Embedded Channel Layout Information in 1722a AVTP Frames

Frank Bähren, Intel Corp.

Layouts with less than eight channels

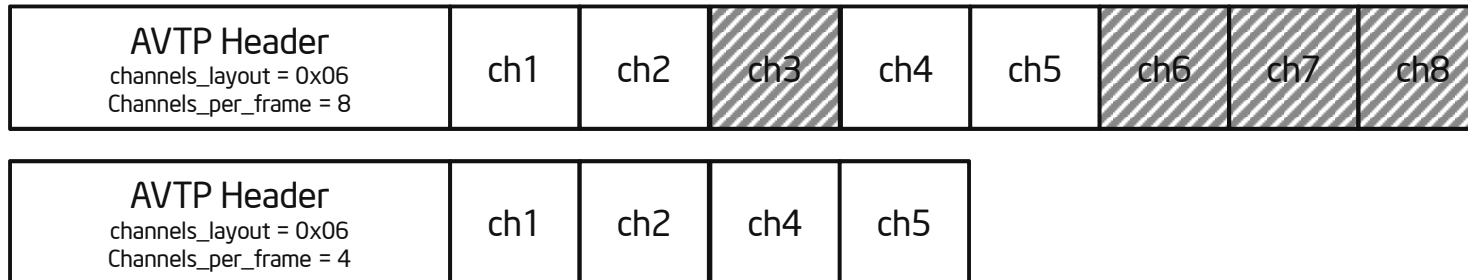
- **Example: Layout 0x06 (Front left/right, rear left/right only)**
 - only four out of eight channels carry data
 - should the other four channels be transported at all?

- **The standard would allow both variants, the simple one and the bandwidth-optimized one**
- **Profiles of industry associations could mandate one form for use in a certain context**
